DIPACO
DIESEL
PARTS
 U S A

FI-43

New Cummins Front Cover and Main Shaft Seal

New Style Front Cover

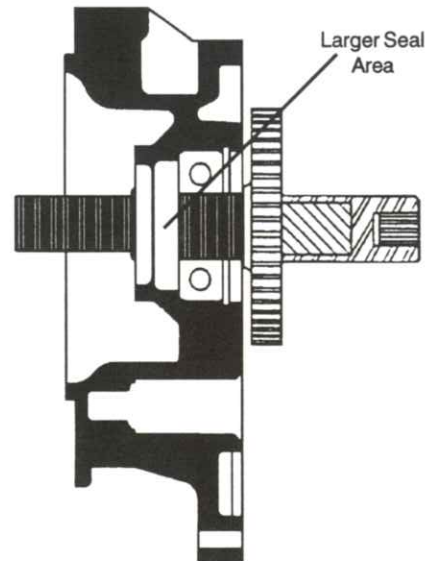
There are four new front cover housings covering automotive, VS, Pacer heavy automotive, and heavy VS applications. The difference between the old and new covers is the seal bore, on the fuel side of the cover,

has been enlarged and modified to accommodate a larger main shaft seal. The chart on the left shows old and new front cover part numbers. Older style front covers can continue to be used. DIPACO has available both

The drawing on the right shows a front cover with the enlarged seal area on the fuel side and the normal seal area on the oil side.

The change in the front cover design was driven by the design of the new main shaft seal, part number 3075523. The new seal has a teflon lip and a larger, rubber coated outside diameter. The teflon lip is used instead of the usual rubber lip to reduce leaks between the seal and the main shaft. It also reduces shaft wear caused by the low lubricity of diesel fuel, as compared to engine lubricating oil. The rubber coating on the outside diameter should reduce leakage between the housing and the seal. DIPACO also has this new seal available, part number **D3075523**.

The **D3075523** seal replaces the **D3062676** seal **ONLY** on the fuel side of the main shaft. The **D3062676** seal **WILL** continue to be used on the oil side of the main shaft.
